GIRDER ~ G3E

SHOP DRAWING REVIEW

GIRDER G3E
VT 78 OVER MISSISQUOI BAY, BRIDGE NO. 2
VT 78 STA.10+970.425 TO STA.12+059.775
TOWNS OF ALBURG AND SWANTON
COUNTIES OF GRAND ISLE AND FRANKLIN
STATE OF VERMONT, AGENCY OF TRANSPORTATION

STATE CONTRACT OR REF. NO. BRF-036-1(1)
CONTRACTOR CIANBRO CORPORATION
IN CHARGE: GLIDDEN (IH) MADE BY: ERS CHK'D. BY: CS DATE: 8-19-04
CONTRACT NUMBER: VT-04057-1 DRAWING NUMBER: 19 OF 112

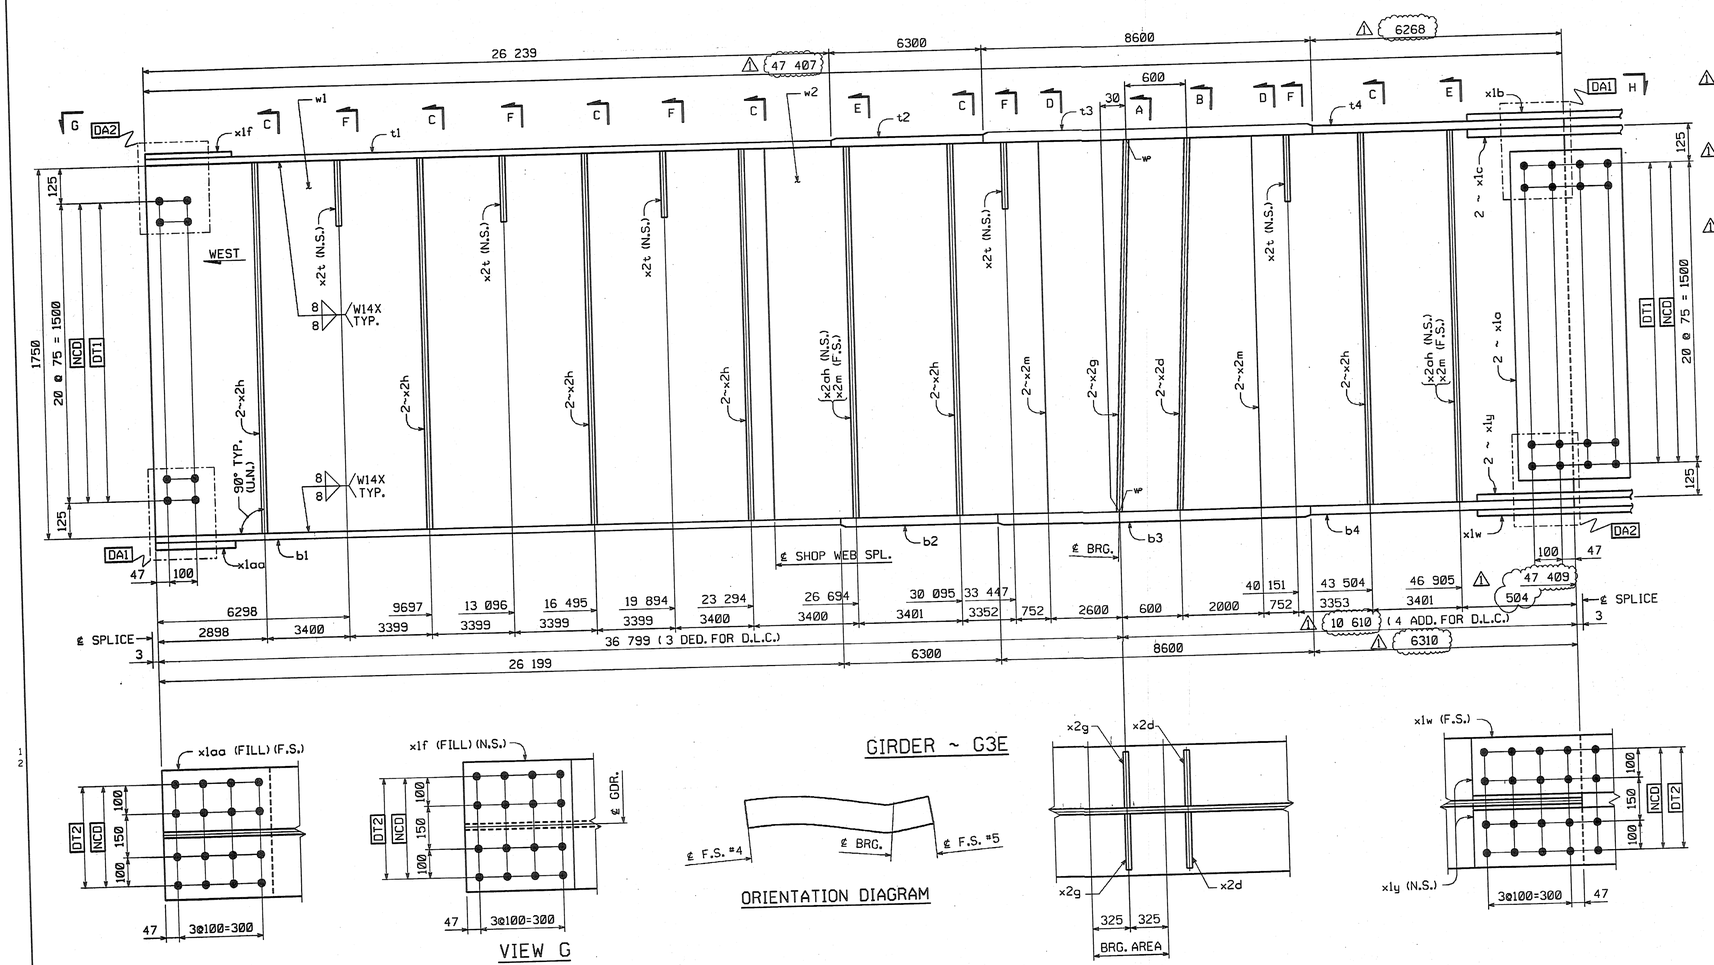
NO.	REVISION	BY	DATE
	INCREASE LENGTHS TO SATISFY REQUIREMENTS FOR LENGTH @ MEAN TEMPERATURE OF 45°F.	DP	9/17/04

NO.	MARK	DESCRIPTION	LENGTH	REMARKS	GRP.	ITEM	SHIP. WT. KG. EA.
ONE	G3E	GIRDER					22 640
~~1~~	w1	PL 16 x 1750	23 810	(T)	3	6	~~5232.84~~ 10420.50
1	w2	PL 16 x 1750	~~23 609~~ 47408	(T)	3	2	~~5188.66~~ 10420.25
1	t1	PL 22 x 450	26 239	(T)	4	18	~~2038.93~~ 2039.16
1	t2	PL 32 x 450	6 300	(T)	4	15	~~712.07~~ 712.15
1	t3	PL 65 x 450	8 600	(T)	4	3	~~1974.44~~ 1974.67
1	t4	PL 32 x 450	~~6 269~~ 6268	(T)	4	16	~~708.57~~ 708.53
1	b1	PL 22 x 450	26 199	(T)	4	20	~~2035.82~~ 2036.06
1	b2	PL 32 x 450	6 300	(T)	4	15	~~712.07~~ 712.15
1	b3	PL 65 x 450	8 600	(T)	4	3	~~1974.44~~ 1974.67
1	b4	PL 32 x 450	~~6 311~~ 6310	(T)	4	14	~~713.31~~ 713.28
2	x1a	PL 12 x 1600	400	(T)	6	1	~~60.28~~ 120.58
1	x1b	PL 14 x 450	790	(T)	6	6	~~39.06~~ 39.07
2	x1c	PL 16 x 200	790	(T)	6	5	~~19.84~~ 39.69
1	x1f	PL 10 x 450	392	FILL	6	7	13.85
1	x1w	PL 14 x 450	790	(T)	6	6	~~39.06~~ 39.07
2	x1y	PL 16 x 200	790	(T)	6	5	~~19.84~~ 39.69
1	x1aa	PL 10 x 450	392	FILL	6	7	13.85

TOTAL WEIGHT THIS SHEET: ~~22 638.53~~ 22638.72 kgs
